Project T10/1711-D

Revision 08
17 January 2006

Information technology - SCSI / ATA Translation (SAT)

Letter Ballot Comment Summary (click text bubble for explanation)

Figure 2 — ATA document structure

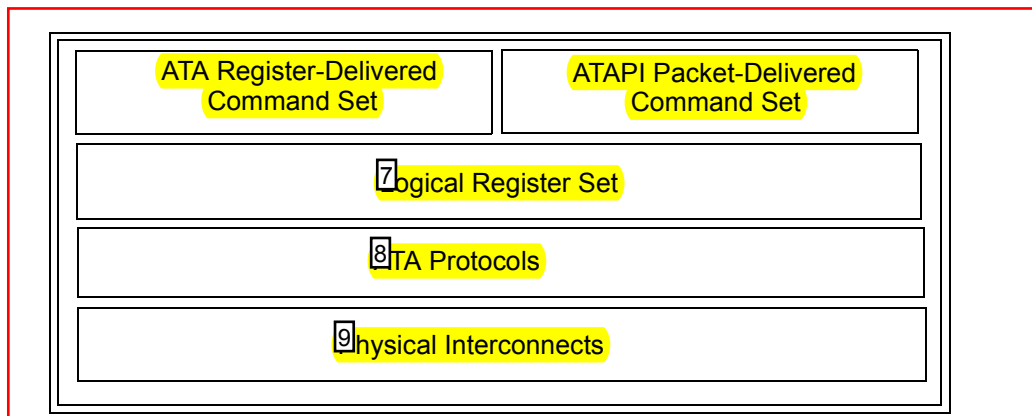
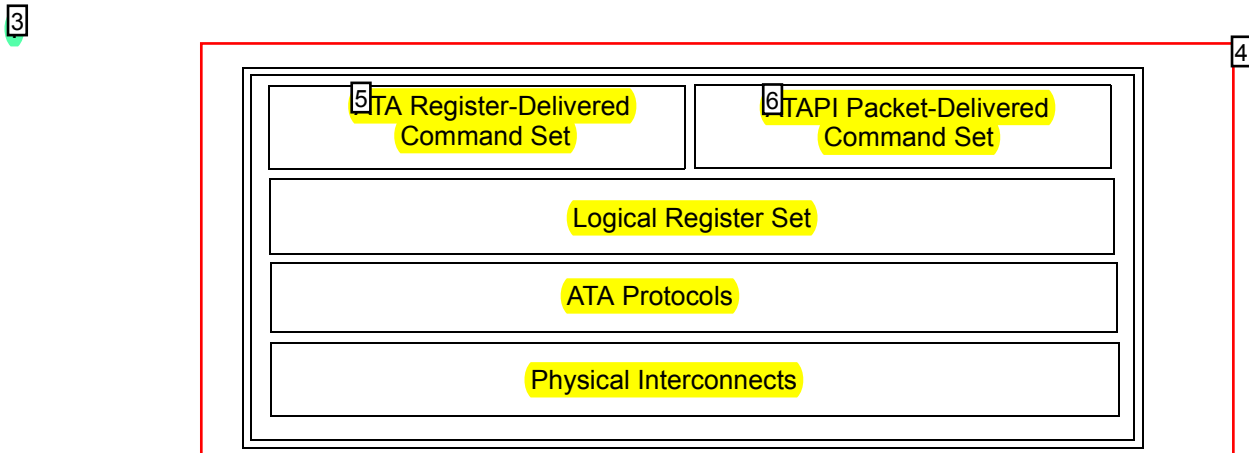
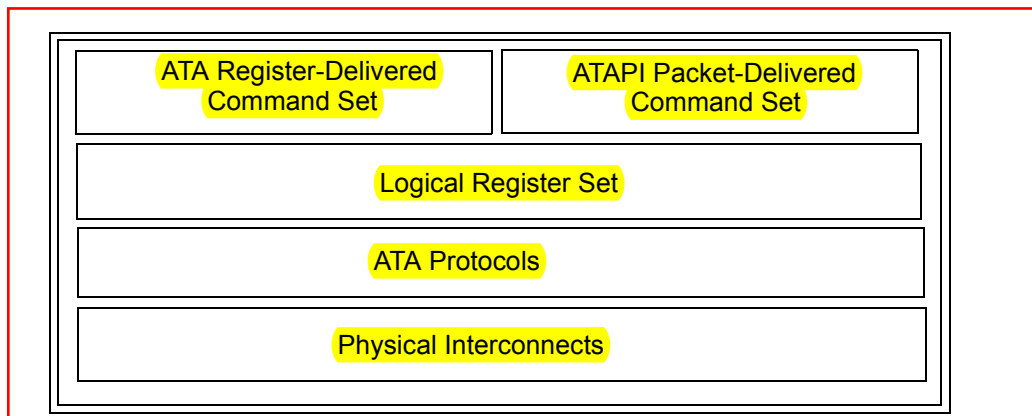
T 1 Scope, the line just before figure-2
Change "ATA/ATAPI-7" to "ATA8".

T Remove the period below the words "Figure 2 shows ..." and above the actual Figure 2.

T In Figure 2
change
"ATA Register-Delivered Command Set"
to
"ATA register delivered command set"

T In Figure 2
change
"ATAPI Packet-Delivered Command Set"
to
"ATAPI packet delivered command set"
RESOLUTION: s/b "ATAPI packet delivered command sets", for consistency with ATA8-ACS.

T This layer doesn't appear in ATA/ATAPI-7
Figure 2
change
"Logical Register Set"
to
"ATA logical register set"
RESOLUTION: Delete the box containing "Logical Register Set" as it doesn't appear in ATA8-ACS.

T Figure 2
change
"ATA Protocols"
to
"ATA Transport Protocols"

T Figure 2
change
"Physical Interconnects"
to
"ATA physical interconnects"

Figure 3 — SCSI/ATA translation document role

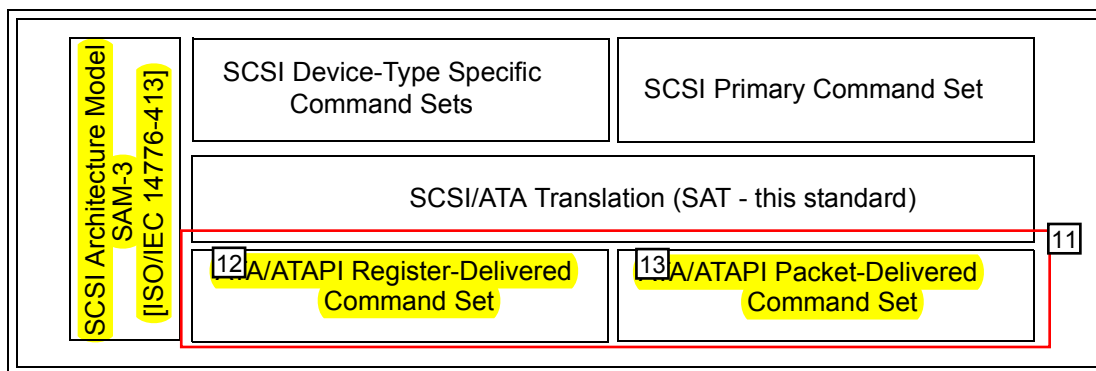
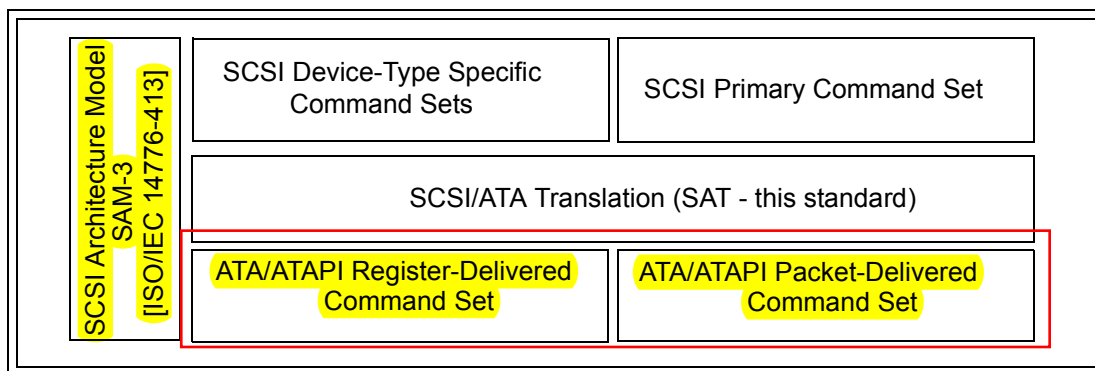
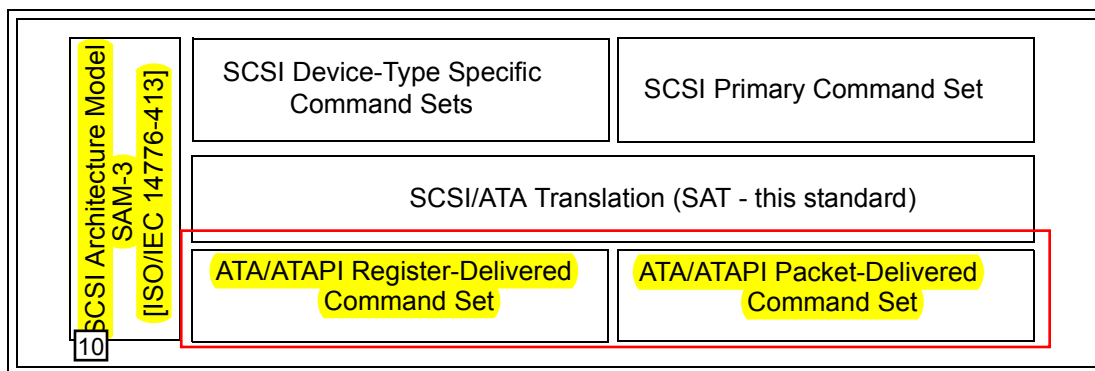
T In Figure 3, remove
"SAM-3
[ISO/IEC 14776-413]"

Figure-3, bottom two boxes:

Figure 4 — SATL functional protocol reference model

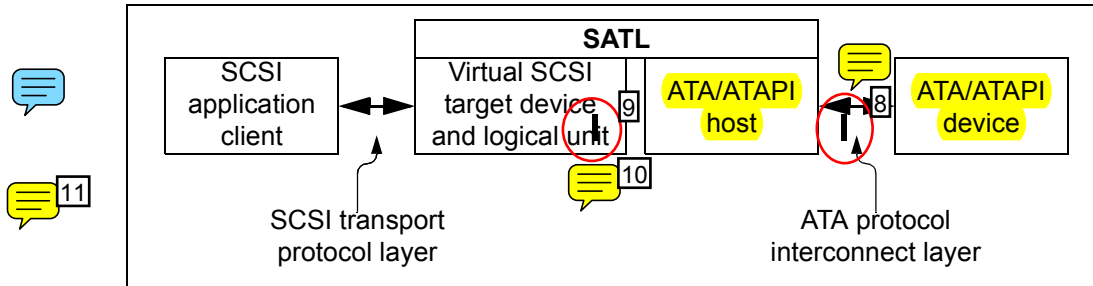
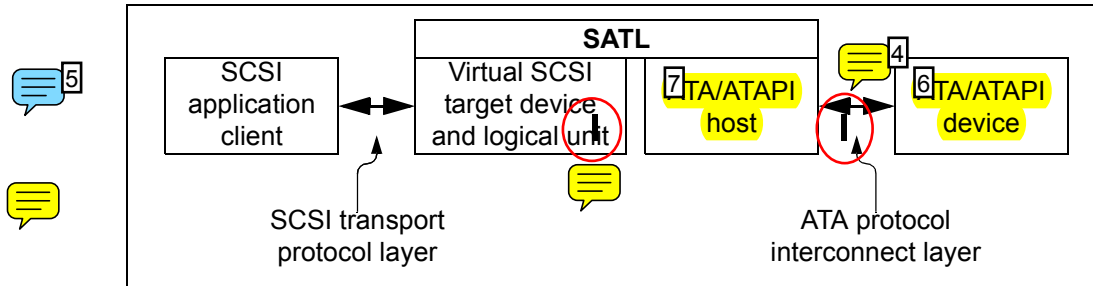
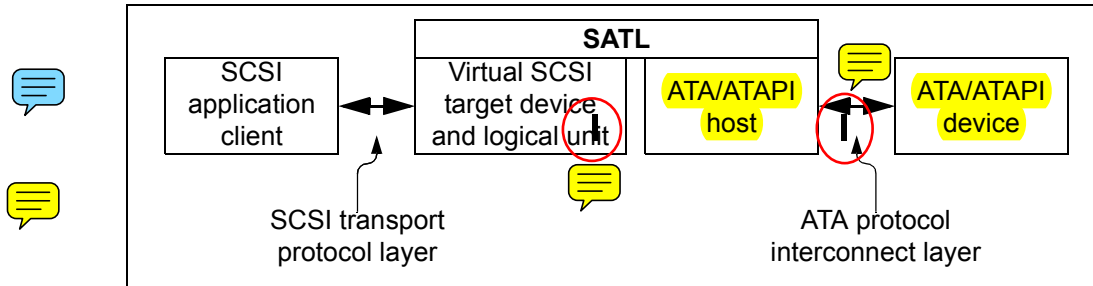
T 5.1 [SCSI architectural elements] Overview, first paragraph: change to, "Clause 5 defines SCSI/ATA translation elements that impact the representation of the storage domains defined in SAM-3 and ATA8-AAM. Figure 4 shows a SATL connecting a SCSI application client to an ATA/ATAPI device.

Figure 4 - SAT functional protocol reference model
change
"ATA/ATAPI host"
to
"ATA host"

5.1
figure 4
remove extra lines in figure

Figure 4
This figure has some strange fat lines in it that need to be removed.

1. Remove what look like change bars in Figure 4
2. Change "logical unit" to "logical unit(s)"
3. Change "ATA protocol interconnect layer" to "ATA transport protocol interconnect layer"

T 5.1 [SCSI architectural elements] Overview, second paragraph: delete the first sentence ("Figure 4 shows a SATL connecting a SCSI application client to an ATA/ATAPI device.") as it is now included in the paragraph before the figure based on the previous comment. Change the remaining sentence to, "The SATL accomplishes this connection by:"

Sequence number: 14
Author: ENDL[RWeber]
Date: 2/14/2006 7:46:55 PM
 1st a,b,c list under figure 4
List entry d) appears to be a regular paragraph, not a list entry.

Change the figure title to: "Figure 4 - Example of a SATL between a SCSI application client and an ATA or ATAPI device", fix change bars, and the change in item-3 as well.

Figure 5 — Identification descriptors included by a SATL in an ATA host

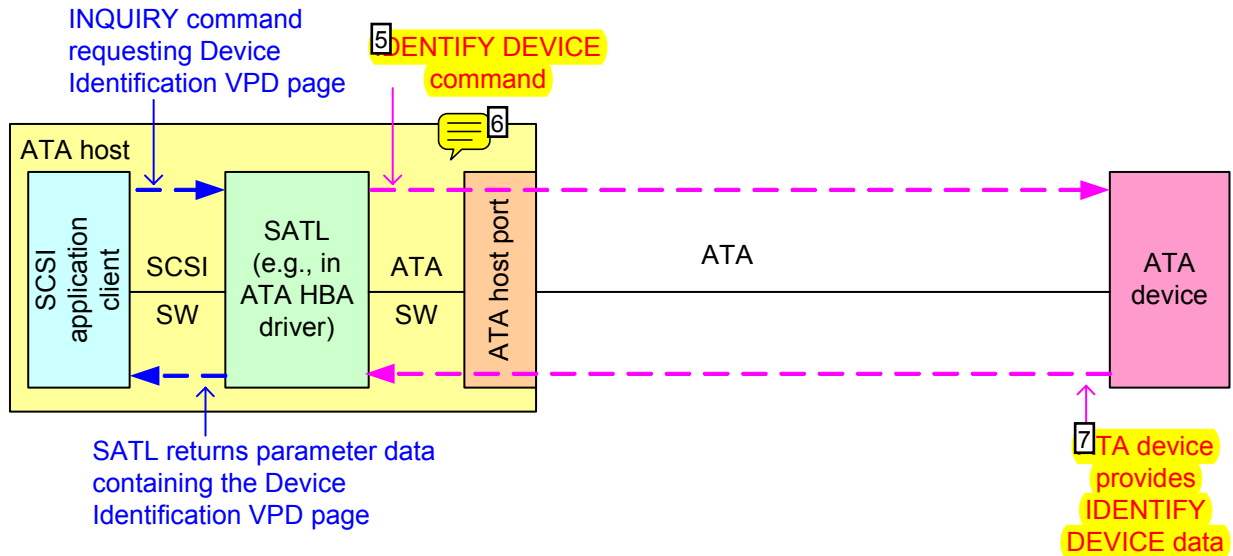
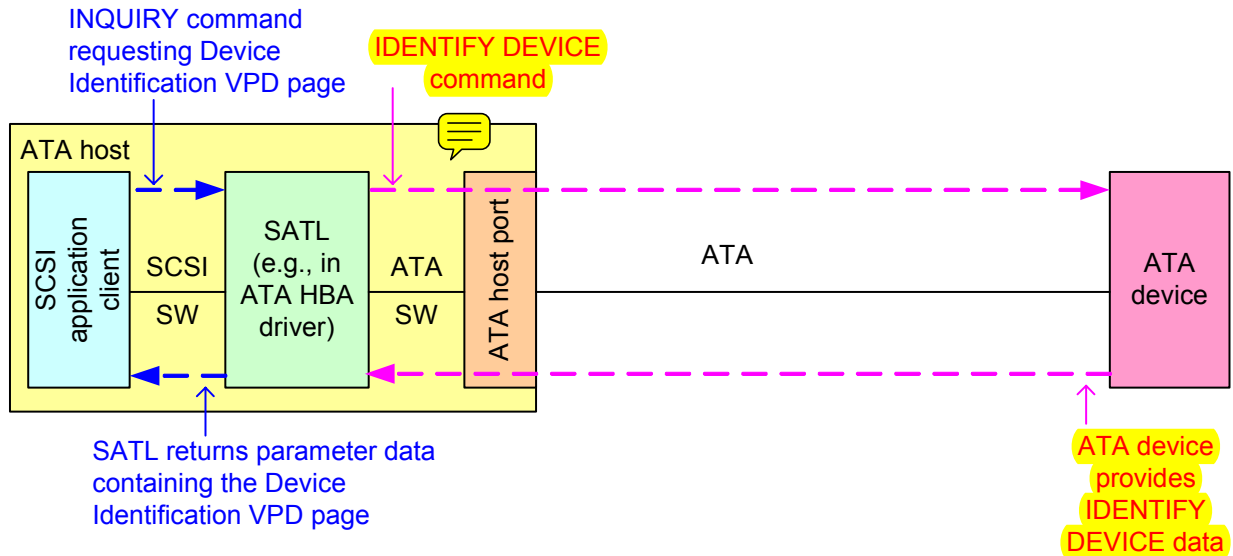
T In **Figure 5 — Identification descriptors included by a SATL in an ATA host**
change
"IDENTIFY DEVICE command"
to
"ATA IDENTIFY DEVICE command"

T In **Figure 5 — Identification descriptors included by a SATL in an ATA host**
change
"ATA device provides IDENTIFY DEVICE data"
to
"ATA device returns ATA IDENTIFY DEVICE data"

Figure 6 — Identification descriptors included by a SATL in a SAS initiator device

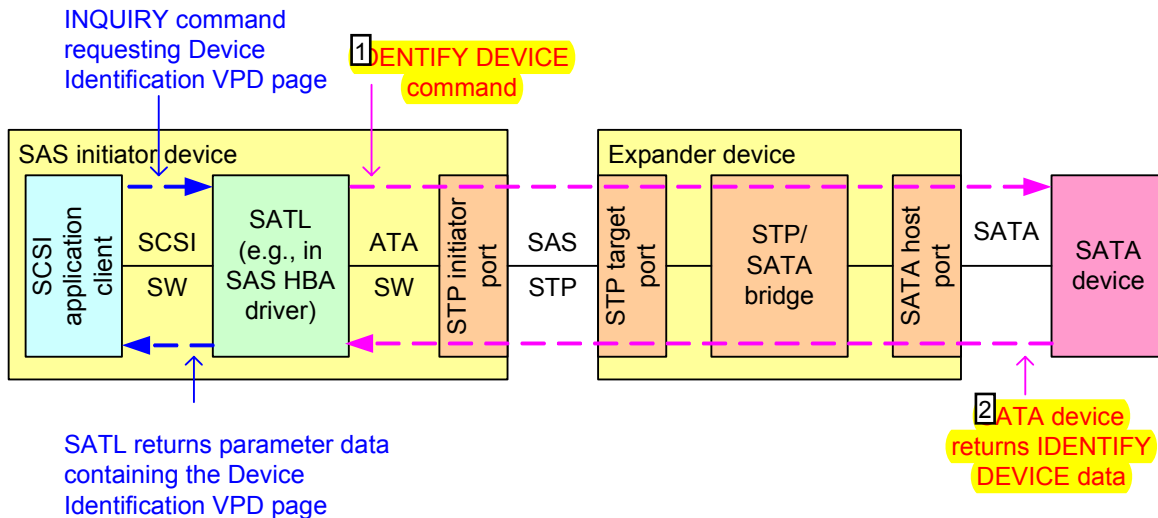
T In **Figure 6 — Identification descriptors included by a SATL in a SAS initiator device**

T In **Figure 6 — Identification descriptors included by a SATL in a SAS initiator device**

Figure 7 — Identification descriptors included by a SATL in a SCSI to ATA protocol bridge

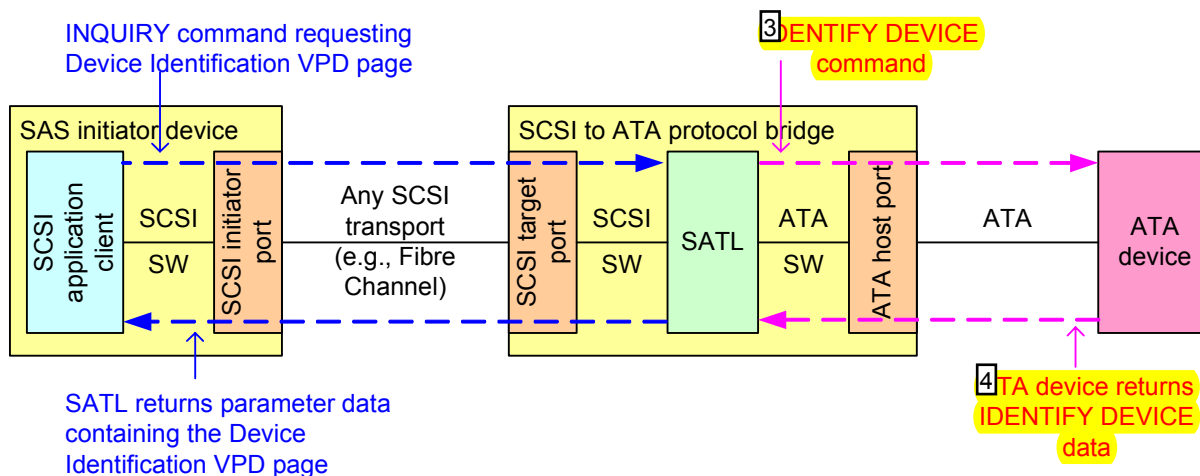
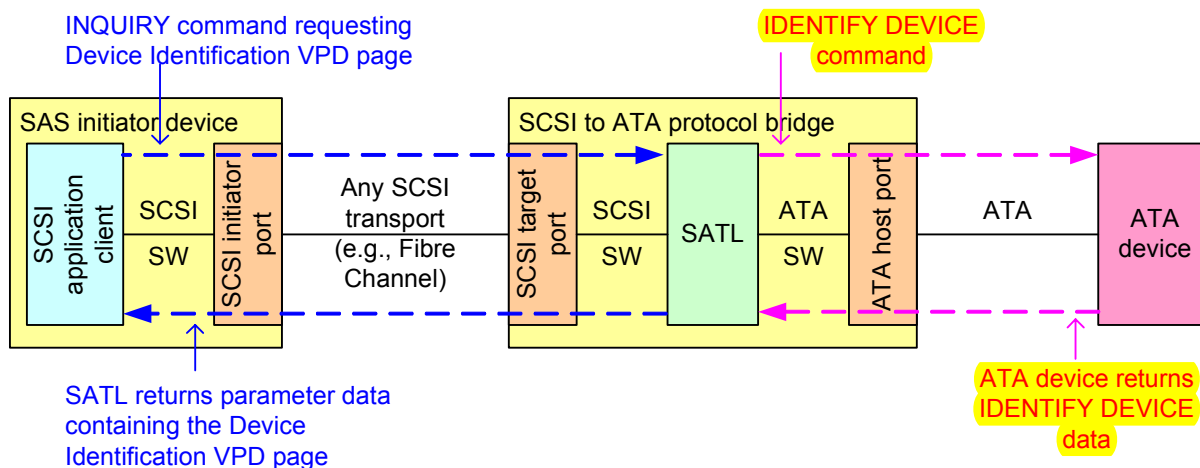
T In **Figure 7 — Identification descriptors included by a SATL in a SCSI to ATA protocol bridge**
change
"IDENTIFY DEVICE command"
to
"ATA IDENTIFY DEVICE command"

T In **Figure 7 — Identification descriptors included by a SATL in a SCSI to ATA protocol bridge**
change
"ATA device returns IDENTIFY DEVICE data"
to
"ATA device returns ATA IDENTIFY DEVICE data"
